THE INDIANAPOLIS PUBLIC LIBRARY

EXTERIOR SIGNAGE REPLACEMENT

ADDENDUM 1

ANSWERS TO QUESTIONS SUBMITTED BY BIDDERS

Sheet Number
B1

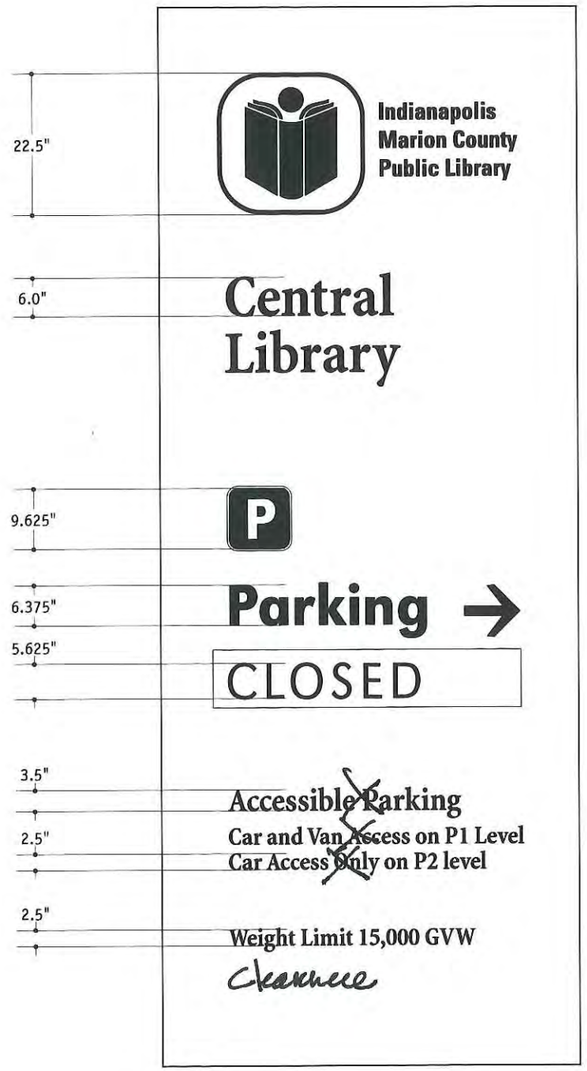
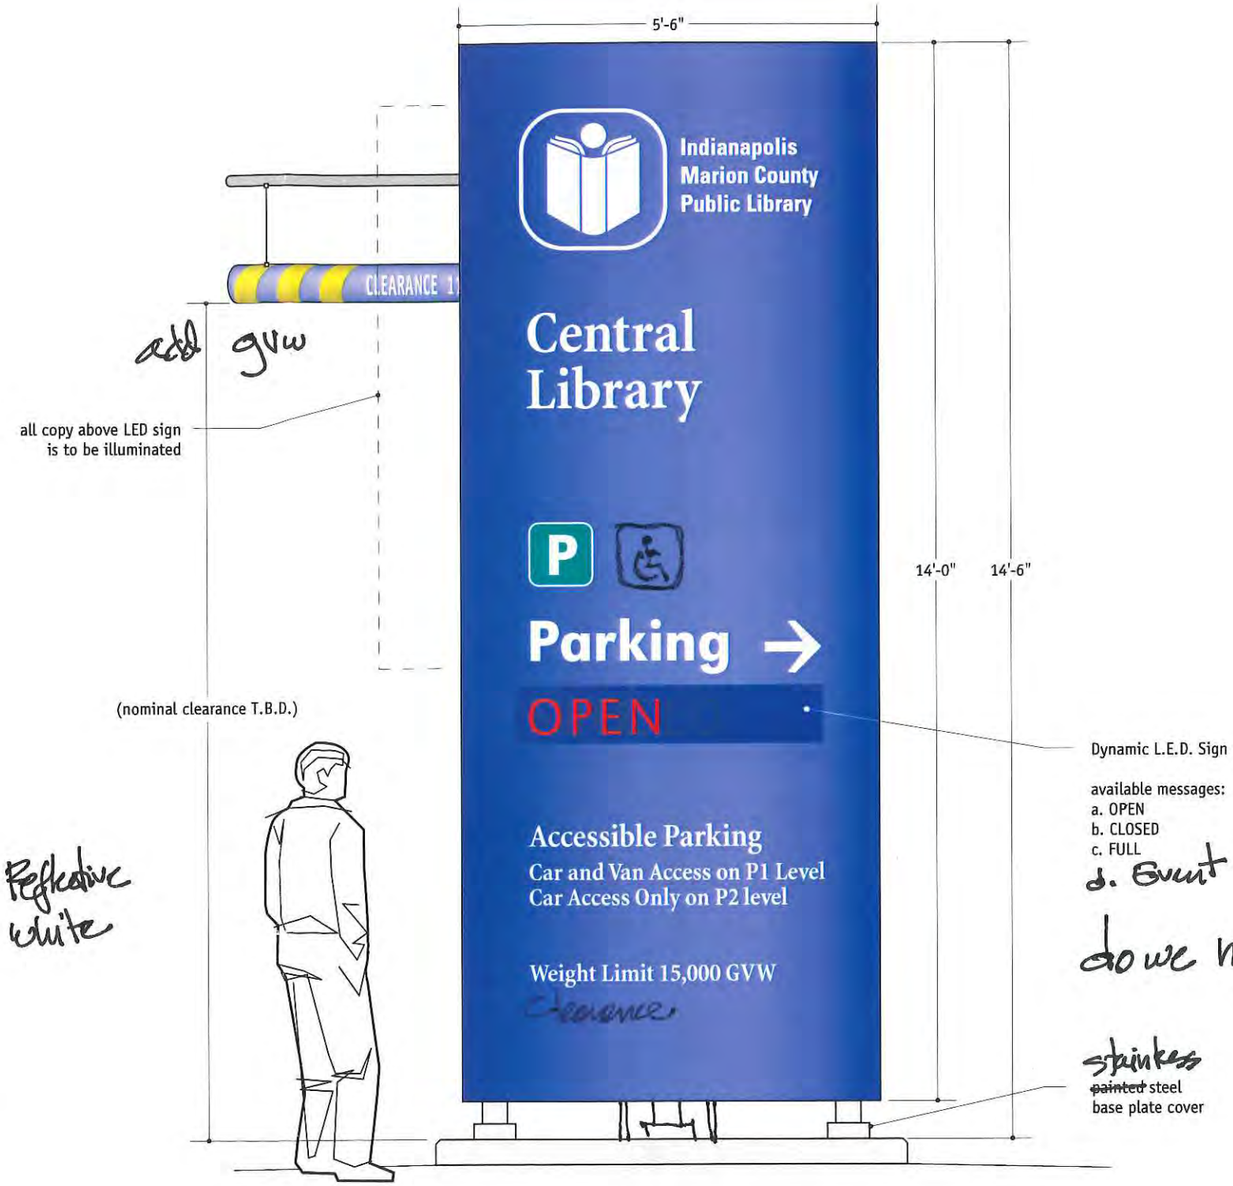
.18 What are the requirements for the Central Garage Pylon?
Answer: The face of the existing internally illuminated plyon sign with the text is to be replaced with a new aluminum panel with push through white text. For a description of the existing pylon sign construction, refer to the attached design intent drawings dated July 25, 2005, prepared by RLR Associates.
